**TOWN OF GLASTONBURY
BID NO. GL-2020-13**

**GLASTONBURY BOULEVARD
PAVEMENT REHABILITATION
STATE PROJECT L053-0003**

**ADDENDUM NO. 2
APRIL 13, 2020**

CPI-BAO-1

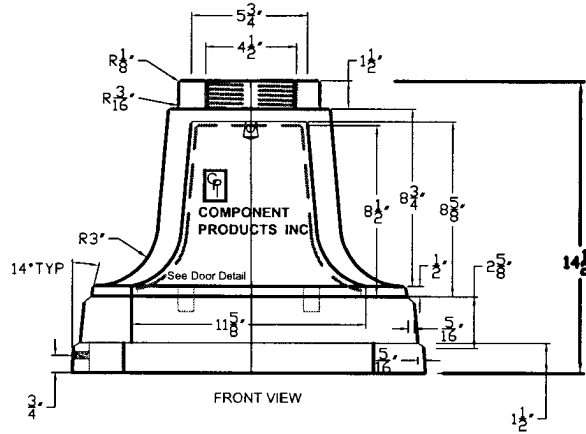
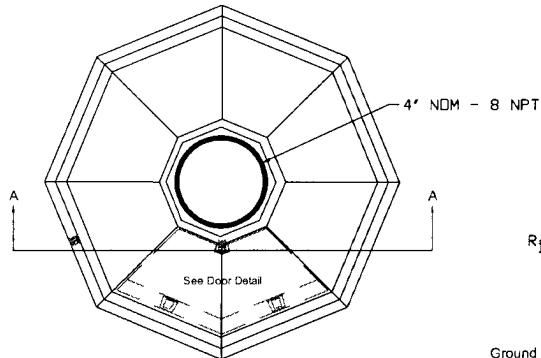
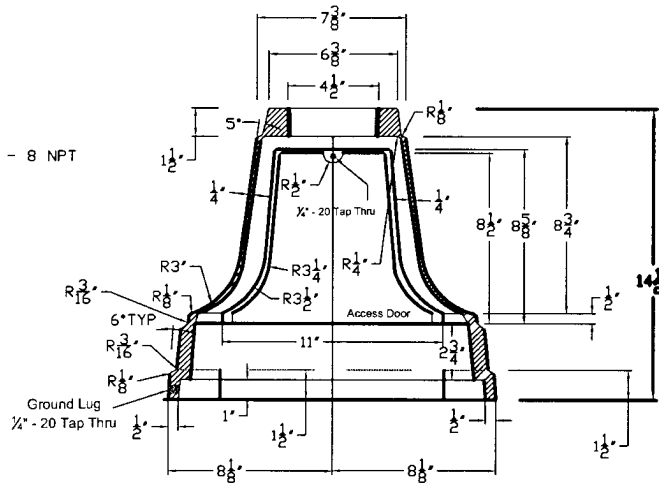
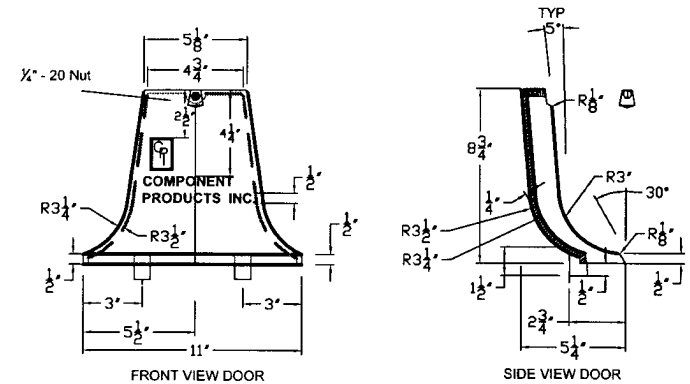
Add the following to the section titled **Materials**: "Ornamental Base for RRFBs shall be Aluminum Octagonal Base Model Number CPI-BAO-1 as supplied by New England Traffic Solutions, Inc. of Glastonbury CT or approved equal."

A detail for this base is provided as an attachment to this addendum.
